STATE OF NORTH CAROLINA
DEPARTMENT OF TRANSPORTATION

SUBJECT: **Addendum to Revision Request for Section 404 Regional General Permit No. 31 and Section 401 General Water Quality Certification No. 3886** for the proposed Interstate 85 (I-85) Widening and Interchange Improvements from north of NC 73 (Davidson Highway / Exit 55) to north of SR 2180 (Lane Street/Exit 63), Cabarrus & Rowan Counties, Divisions 9 and 10. Federal Aid Project No. FANHIMF-085-2(61)55, TIP Project No. I-3802A.

In addition to this letter, please find enclosed revised Wetland and Stream Permit Drawing Sheet Nos. 61 – 64 and 126 – 128 of 128; and drawings depicting the approximate location of the crane mats to be used at Site 18.

PERMIT DRAWING SHEET 63 OF 122
MODIFICATION
 11/3/2017

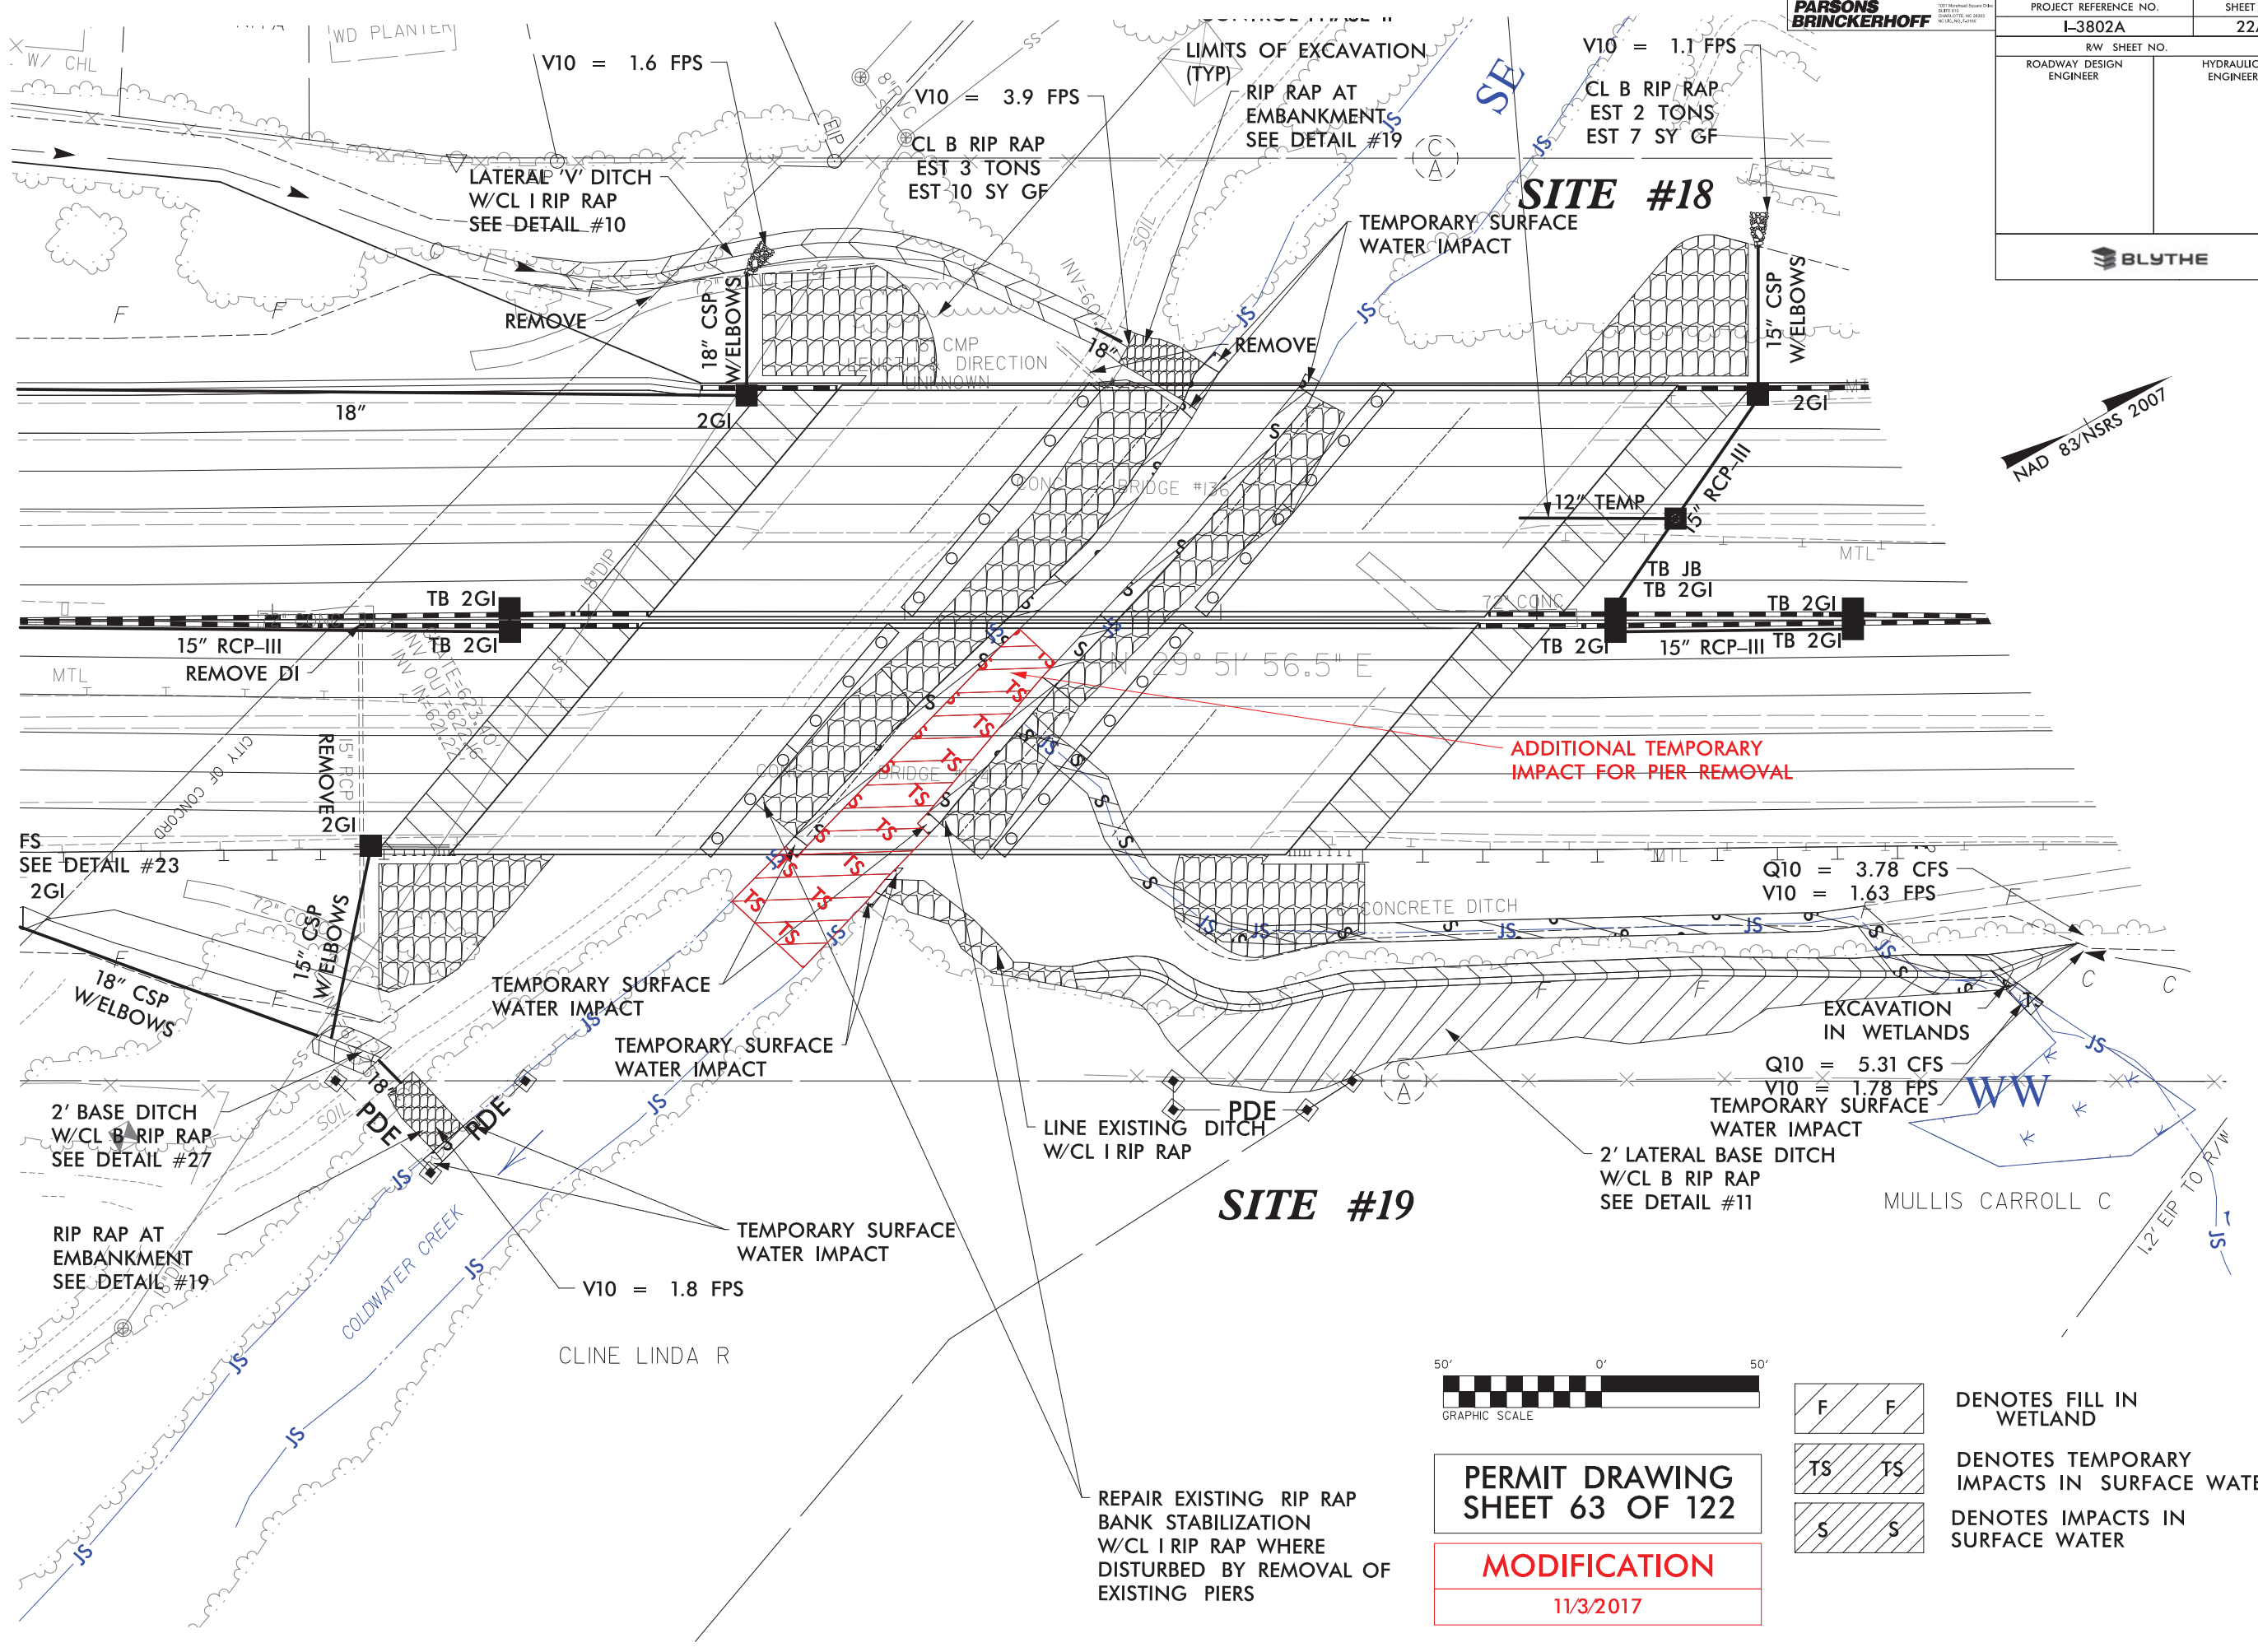
In order to assist with demolition of the existing bridge, crane mats will be placed into Cold Water Creek, resulting in temporary surface water impacts. The crane mats are 4 – foot wide by 1 – foot thick oak timbers that will be placed in the stream bed by an excavator from the bank. Two parallel rows of mats will run 125 feet within the stream channel. The excavator will place the bucket on the furthest timber from the bank and elevate its tracks to load itself onto the closest timber. Once the front portion of the tracks are on the timber it will position itself on both timbers by rotating 90 degrees and placing the bucket once again on the crane mats. While on the crane mats, Type 2 fabric will be secured across the creek channel and under the excavator to catch any demoed debris. Once demolition is complete, the removal process of the crane mats will be in the reverse order as they were placed.

The placement of these mats will result in 125 linear feet (0.07 acres) of temporary surface water impacts. A portion of this impact overlaps with the bank stabilization impacts at this site, but is occurring in a portion of the channel that was not impacted by the bank stabilization.
